SERVICE BULLETIN

PURPOSE : CHANGE	ISSUE NO. : MSB-14EXML34-001A	DATE : 2014-07-07
SUBJECT : SHOCK ABSORBER ASSEMBLY INSTALLATION		<DESTINATION/MODEL> (MMNA/USTP/EUR/RUSSIA /G.EXP/GCC/MMAL/NZ) OUTLANDER SPORT/ASX(GA0W) <M/Y> 13-15
GROUP : REAR SUSPENTION(Gr:34)

Please refer to the attached document for the information about the change of mention in the applicable service manual. (The procedure of how to install the shock absorber assembly has been changed)

<Incorrect> A

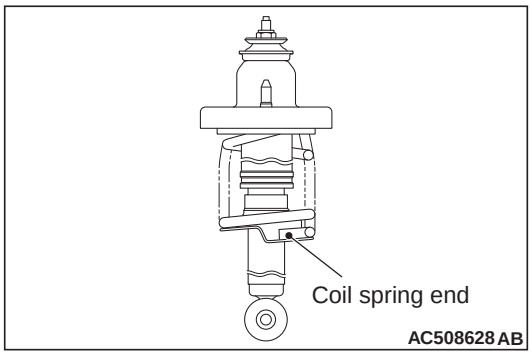
<Old> **INSTALLATION SERVICE POINT**

~~For installation service points, follow the same service procedures as 10 MY OUTLANDER.~~

~~**<Vehicles for Europe>**~~

~~• The procedure is the same as that for 10 MY OUTLANDER.~~

~~**<Vehicles for Russia>**~~

~~• Install the shock absorber assembly so that the coil spring end faces the rear of the vehicle.~~

<Correct> A

<Vehicles for Europe> <Vehicles for Russia (Old)>
Install the shock absorber assembly so that the coil spring end faces the rear of the vehicle.

<Vehicles for Russia (New)>
The procedure is the same as that for 10 MY OUTLANDER.

<Old> >>A<< SHOCK ABSORBER ASSEMBLY INSTALLATION

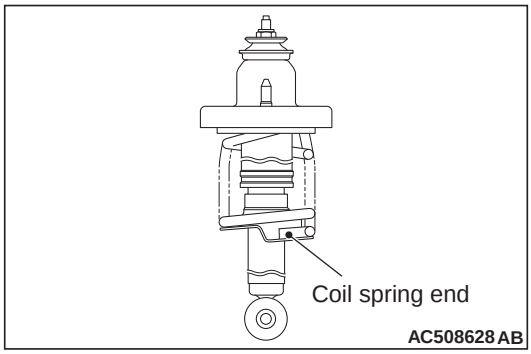
~~Install the shock absorber assembly so that the coil spring end faces the rear of the vehicle <LH>, or the coil spring end faces the front of the vehicle <RH>.~~

~~**<Except vehicles for General Export (MMNA production)>**~~
- ~~Install the shock absorber assembly so that the coil spring end faces the rear of the vehicle <LH>, or the coil spring end faces the front of the vehicle <RH> .~~

~~**<Vehicles for General Export (MMNA production)>**~~
- ~~Install the shock absorber assembly so that the coil spring end faces the rear of the vehicle.~~

<Correct> A

<Except MMNA production> <MMNA production (Old)>
Install the shock absorber assembly so that the coil spring end faces the rear of the vehicle.

<MMNA production (New)>
The procedure is the same as that for 10 MY OUTLANDER.

<Old> >>A<< SHOCK ABSORBER ASSEMBLY INSTALLATION

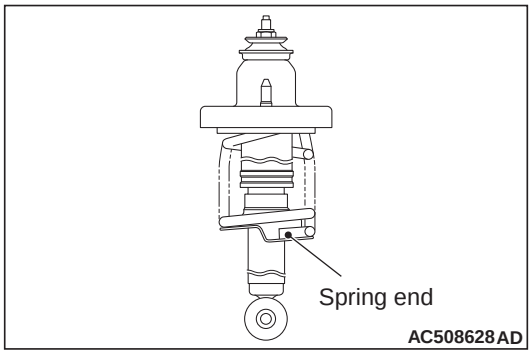
~~Install the shock absorber assembly so that the coil spring end faces the rear of the vehicle <LH>, or the coil spring end faces the front of the vehicle <RH>.~~

~~Install the shock absorber assembly so that the coil spring end faces the rear of the vehicle.~~

<Correct> A

<Old>
Install the shock absorber assembly so that the coil spring end faces the rear of the vehicle.

<New>
Install the shock absorber assembly so that the coil spring end faces the rear of the vehicle <LH>, or the coil spring end faces the front of the vehicle <RH>.
